**Trans Mountain Pipeline ULC (Trans Mountain)
Trans Mountain Expansion Project
Certificate of Public Convenience and Necessity OC-065
Application pursuant to section 211 of the Canadian Energy Regulator Act
Segment 5.3 (Pipsell area)
File OF-Fac-Oil-T260-2013-03 61**

Information Request to Trans Mountain from Stk'emlúpsenc te Secwépemc Nation

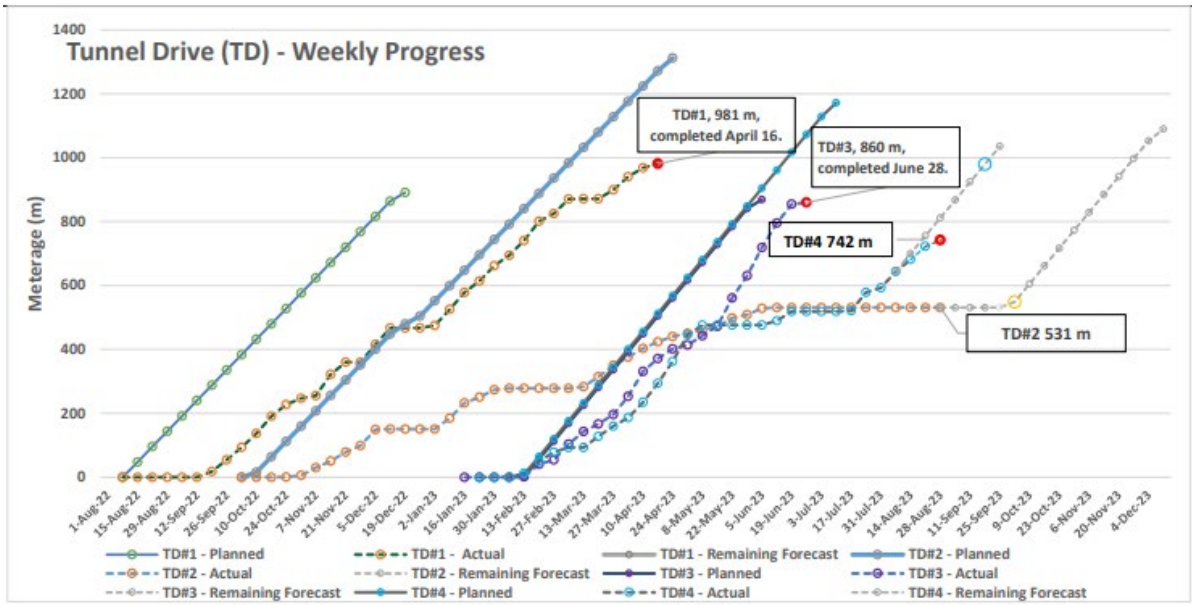
To SSN's knowledge, Tunnel Drive #2 (between Pad 1 to 2) tunneling progress has been inactive approximately 42% of time prior to Shaft-6 construction mainly due to equipment failures. Please provide all relevant information regarding the reason for the lengthy delays on Tunnel Drive #2.

Accordingly, please also provide answers to the following question: Are all other tunnel drives on schedule?

The image below identifies the planned schedules for all of the tunnel drives with respect to actual progress. All of the tunnel drives experienced a slight delay at the beginning of their respective drives which can be described as commissioning and startup of the MTBMs. The delay of Tunnel Drive #4 is attributed to the switch over of contractors (approximately 1 month) and the suspension of Tunnel Drive #4 while Tunnel Drive #3 exits into the shared Launch / Reception shaft (approximately 1 month).
